# Access Compliance Report

## Public Rights-of-Way

### (Curb Ramps)

Intersection ID: 28291	Main Street: COMMUNITY HOUSE RD	Cross Street: ARDREY KELL RD	Location: W
ADA ID: 3D092B308889	Ramp Type: BlendTrans1	Initial Pass/Fail: Fail	Overall Compliance: No
Severity Score: 1.25			
Codes/Mitigation Info/Possible Solution		Field Measurements/Component Compliance

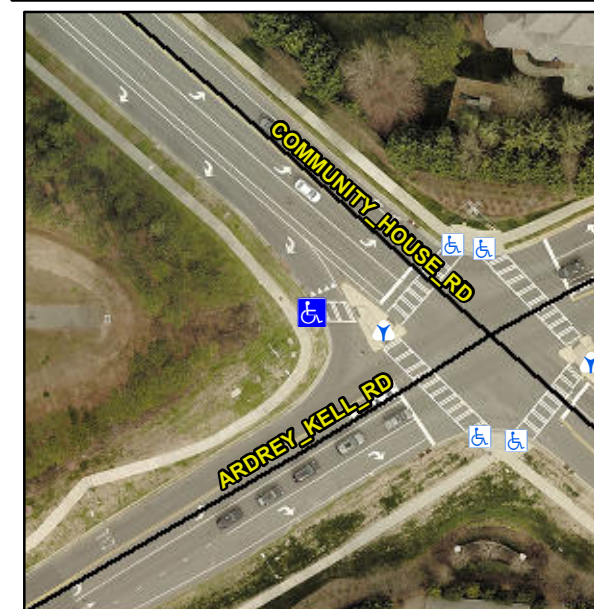
**R304.5.3**

Compliance	Description	Data	Compliance	Description	Data
N/A	Ramp Length (in)	132.0	Yes	BlendTrans Slope (%)	3.4
Yes	Ramp Width (in)	48.0	No	BlendTrans XSlope (%)	2.6
N/A	Flare Type LT	N/A	N/A	Flare Type RT	N/A
N/A	Flare Slope LT (%)	N/A	N/A	Flare Slope RT (%)	N/A
N/A	Flare Traversable LT?	N/A	N/A	Flare Traversable RT?	N/A
N/A	Landing Length (in)	N/A	N/A	DWS Provided?	N/A
N/A	Landing Width (in)	N/A	N/A	DWS Contrast?	N/A
N/A	Landing Slope (%)	N/A	N/A	DWS Length (in)	N/A
N/A	Landing X Slope (%)	N/A	N/A	DWS Full Width?	N/A
N/A	Landing Curb? (Y/N)	N/A	N/A	DWS Offset (in)	N/A
N/A	Shared Landing?	N/A			
N/A	Gutter Ponding?	N/A	N/A	Gutter Slope (%)	N/A
N/A	Gutter Lip Ht (in)	N/A	N/A	Gutter X Slope (%)	N/A
N/A	Painted X Walk1?	Yes	N/A	Painted X Walk2?	N/A
	X Walk 1 Direction	To SE		X Walk 2 Direction	N/A
	X Walk 1 Width (in)	128.0		X Walk 2 Width (in)	N/A
	X Walk 1 Slope (%)	4.6		X Walk 2 Slope (%)	N/A
	X Walk 1 X Slope (%)	0.3		X Walk 2 X Slope (%)	N/A

**Remove & Replace Curb Ramp With Two New Directional Ramps or Equivalent.**
